ADMIRAL 4F4, A, Pre-Amp, and 8L3, A, Power Unit, Continued

SCHMATIC FOR 4F4, 4F4A PRE-AMP CHASSIS

SCHMATIC FOR 8L3, 8L3A AMPLIFIER - POWER SUPPLY CHASSIS

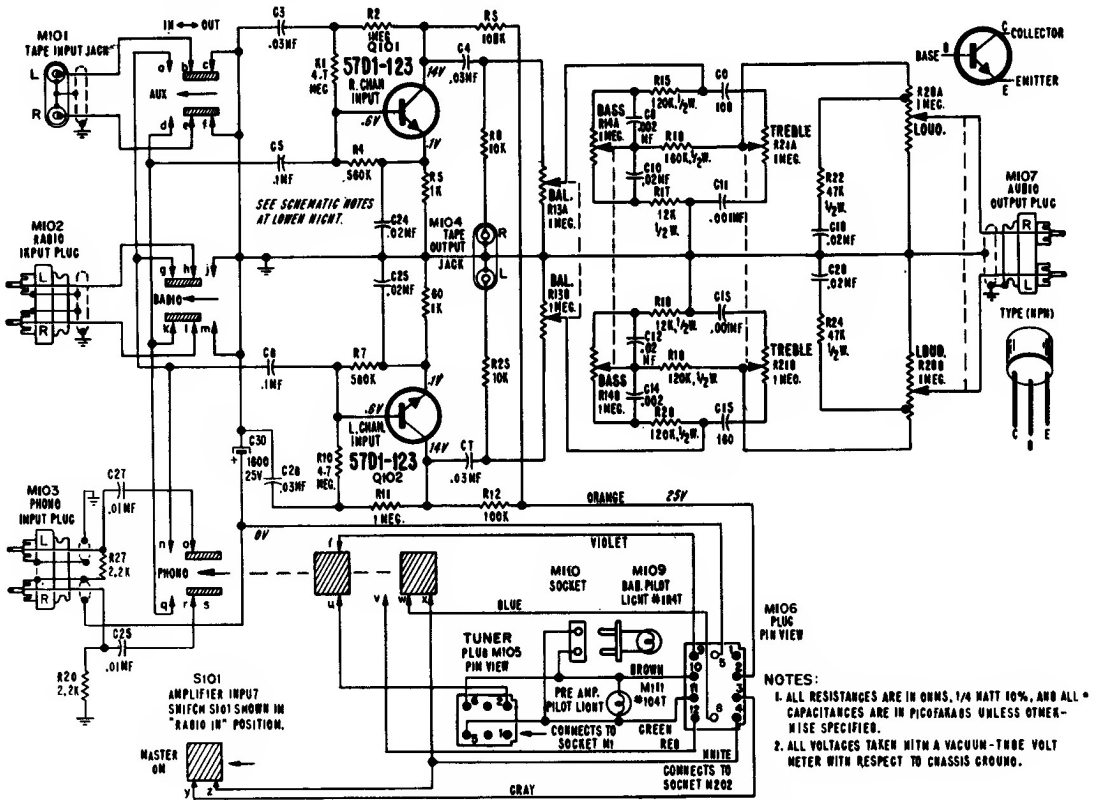
- (10) Start of production. (11) (12) No service significance.
- (13) For reduced background noise, R214 & R214 changed from 62K to 51K, 5%. C203 & C204 changed from 5701-124 to 5706-19.
- (14) For proper phase relation of AC leads with resulting reduction of hum at max volume level, T204 & M204 lead color code changed as shown on schematic.
- (15) To eliminate possibility of low frequency motor boating in case of speaker mismatch, C205 & C209 changed from 470pF to 20pF.
